**DEPARTMENT OF TRANSPORTATION****Federal Aviation Administration****14 CFR Part 39**

[Docket No. FAA–2024–0237; Project Identifier AD–2023–00491–R; Amendment 39–22853; AD 2024–19–11]

**Airworthiness Directives; Robinson Helicopter Company Helicopters**

**ACTION:** Final rule.

Figure 1 to Paragraph (g)(1)(i)—Flex Plate Inspection

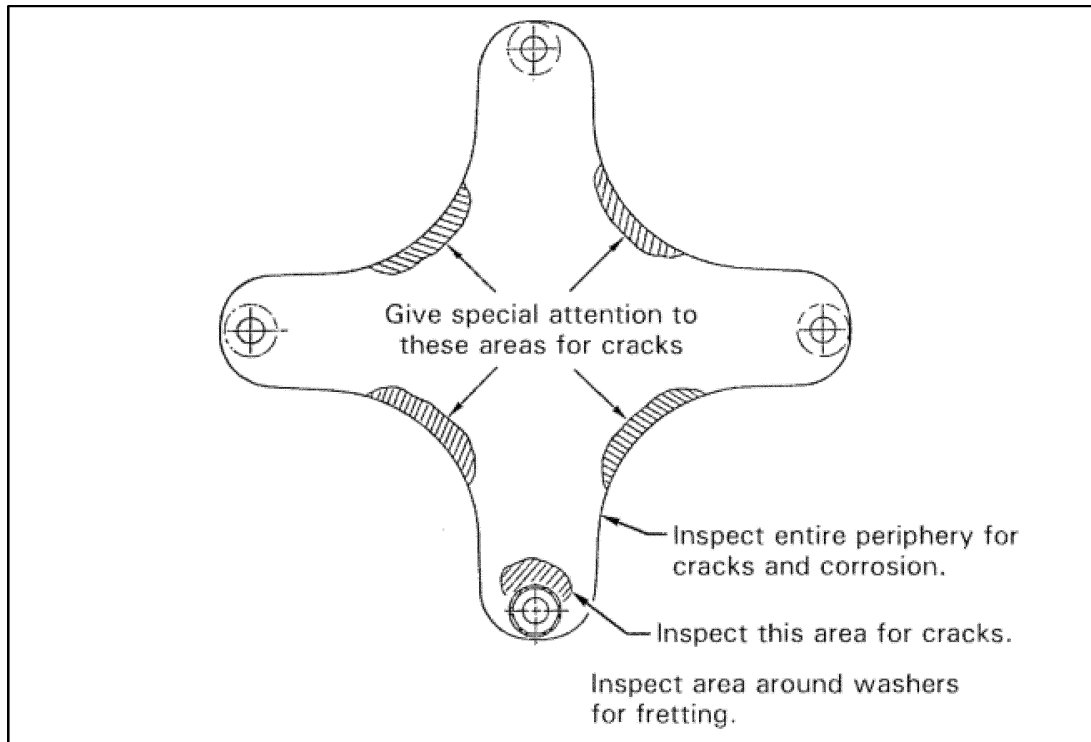
(i) Visually inspect forward flex plate assembly (flex plate) part number (P/N) C947-1 for any loose fasteners, cracks, fretting, corrosion, wear, and to ensure that the washers are bonded to both sides of each flex plate arm, in the areas depicted in Figure 1 to paragraph (g)(1)(i) of this AD. If there is any loose fastener (can be moved by hand), crack, fretting, corrosion, or wear that consists of the washers not securely bonded to both sides of each flex plate arm, before further flight, remove the flex plate from service and replace with an airworthy flex plate.

**Note 1 to paragraph (g)(1)(i):** The flex plate may be installed in order to accomplish the visual inspection.
